PROJECT: Summerlin V25 Sky Vista Drive Imp.

CITY OF LAS VEGAS INTER-OFFICE MEMORANDUM				DATE: April 22, 2019
TO: **Land Development Services** Department of Building & Safety				FROM: Albert Sung, P.E. Flood Control Project Engineer Department of Public Works
SUBJECT:	Drainage Study for: **Summerlin V25 Sky Vista Drive Improvements – Phase 1**			**COPIES TO:** GCW Engineers / Surveyors
Cross Streets:	Sky Vista Drive between Far Hills & Redpoint			Howard Hughes Company
File Number:	F:\Depot\DSMemos\DS5120A.doc			Bart Anderson, P.E., DevCo
Parcel Number:	137-22-101-001			CCRFCD
Zoning Action:				
FEMA Flood Zone	YES	NO	X	
Proposed Storm Drain	YES	NO	X

The Drainage Study for the subject project has been reviewed and:

FIGURE 5
INTERIM CONDITION DRAINAGE MAP

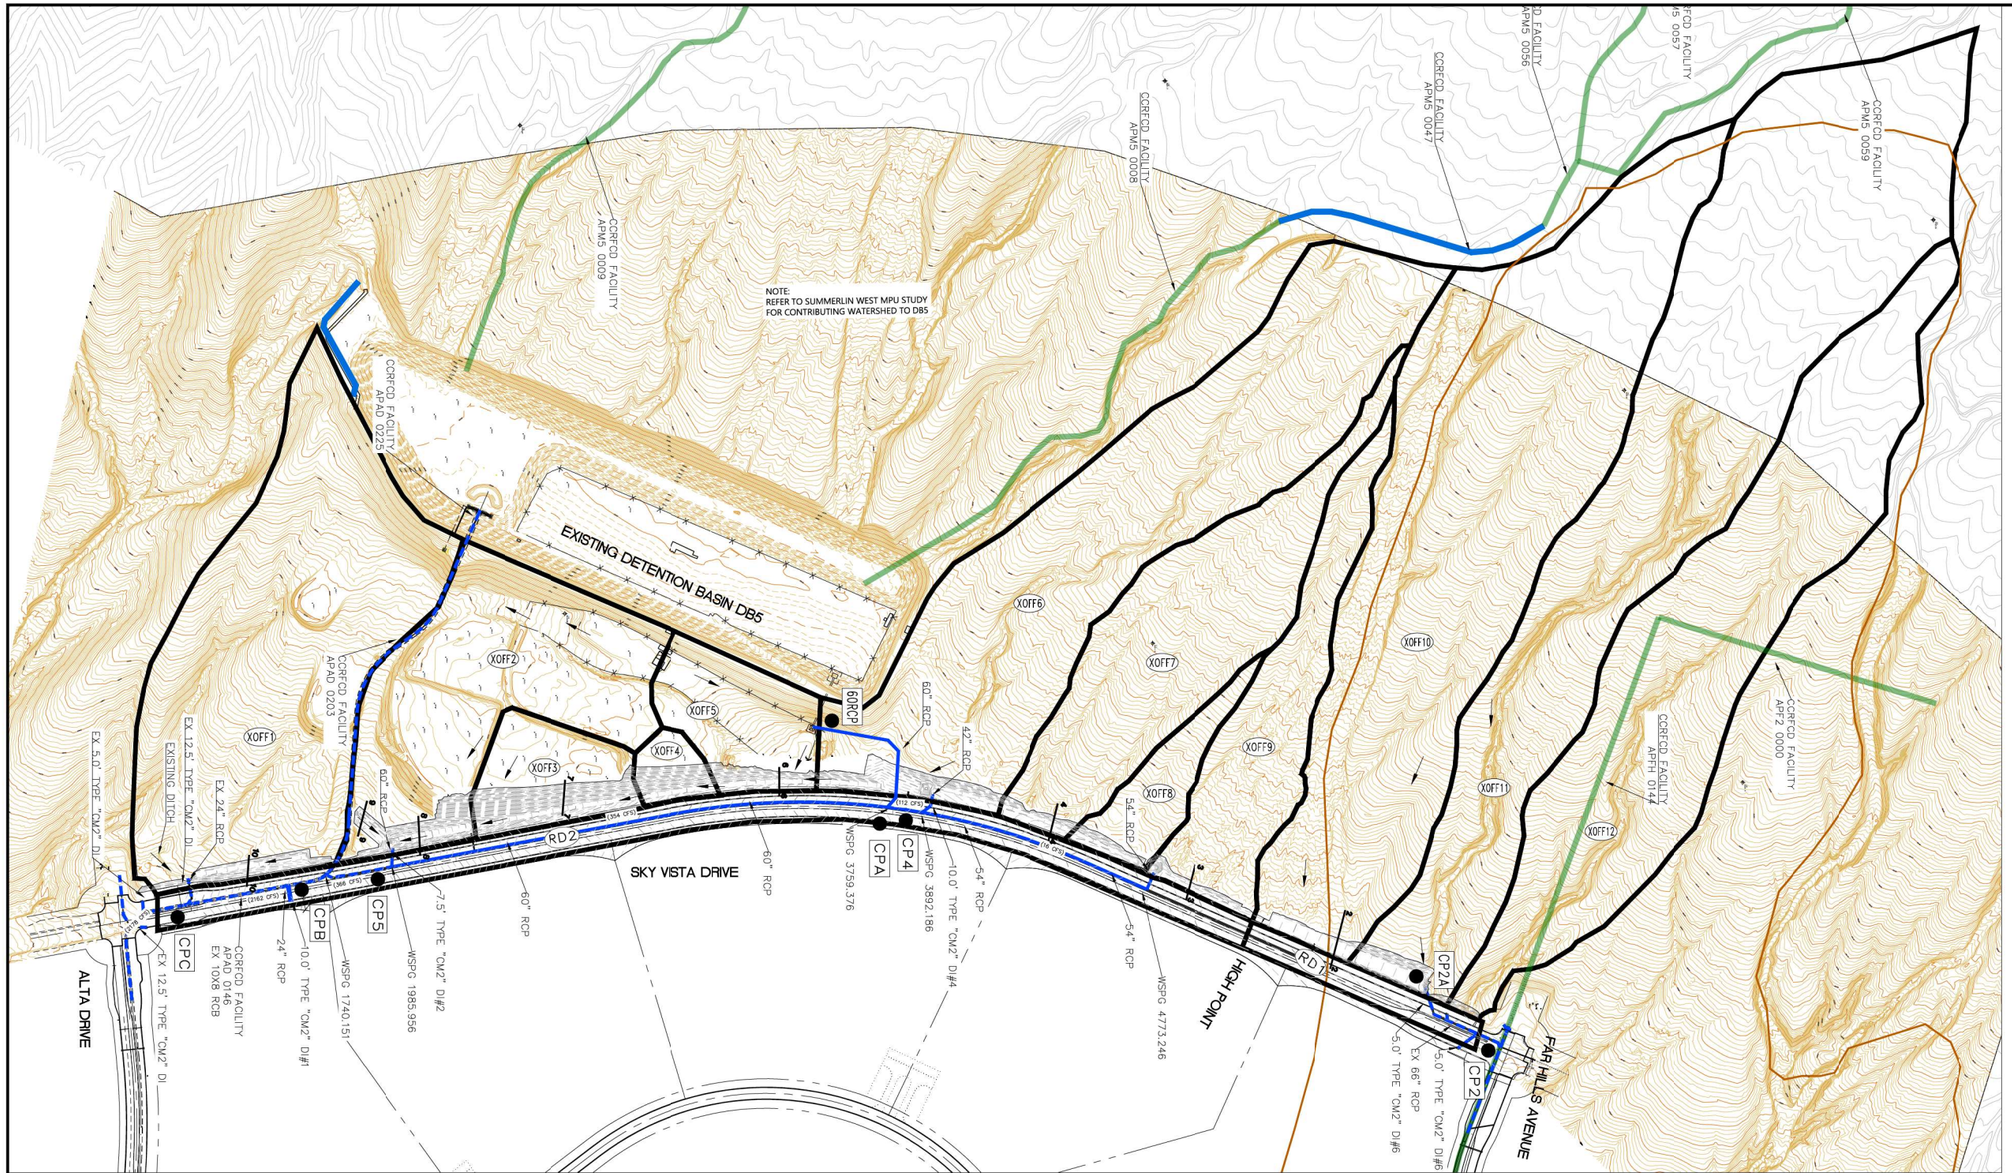
7. Identify the *LVVWD Zone 3665 Reservoir* site on the *Interim Condition Drainage Map (FIG 5)* in the next submittal.

1/– PLAN – JUNCTION 6'x6' RCB TO 8'x6' RCB
SCALE: 3/16" = 1'–0"

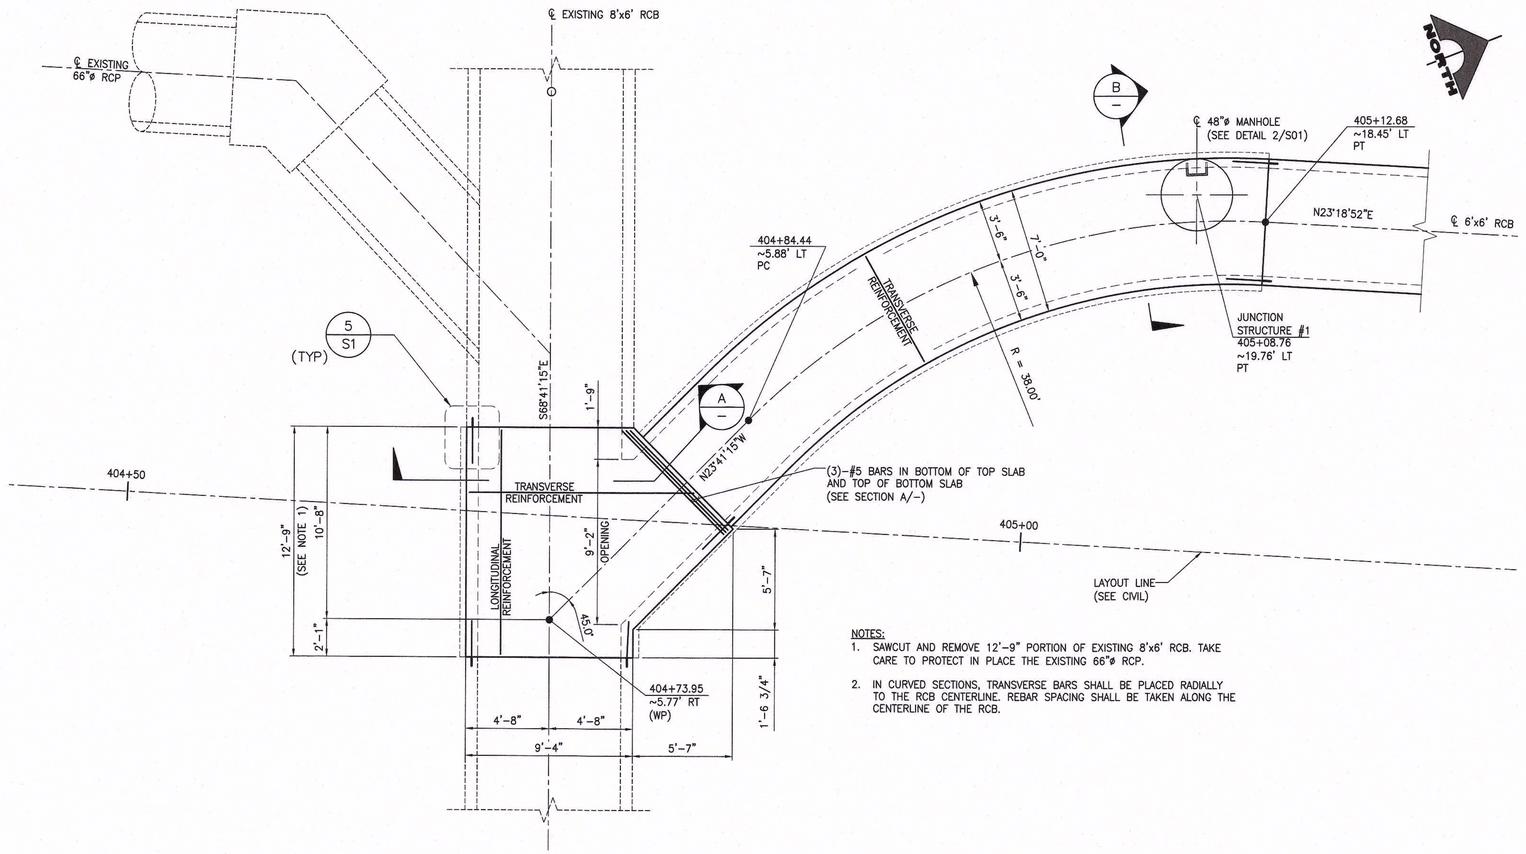
4. The proposed improvement plans show drainage facilities (junction structure connecting the proposed 6'x6' RCB in Sky Vista and the existing 8'x6' RCB in Far Hills) of a size that must be reviewed for Maintenance and Access concerns. The engineer must submit an extra set of improvement plans to *City of Las Vegas Streets & Sanitation Department* for their review. *Streets & Sanitation* approval must be secured prior to drainage study approval.

5. Structural plans for the storm drain improvements such as the junction structure must be submitted for review. Provide a soils report, structural calculations and specifications, two wet stamped structural sets, and a grading plan to the *City of Las Vegas Building Department* for processing. The engineer must provide a copy of *Building Department* approval of the structures to *Flood Control* prior to conditional approval of the drainage study.

6. The flow in the junction structure exceeds the maximum velocity allowed (25 fps) per the *CCRFCD Hydrologic & Hydraulic Design Manual*. The Engineer must provide a detail showing additional sacrificial concrete (1-inch minimum) on the plans. A Special Construction Note must be added to the Improvement Plans and the Plan and Profile Sheet that calls out the special construction requirement for the additional sacrificial concrete.
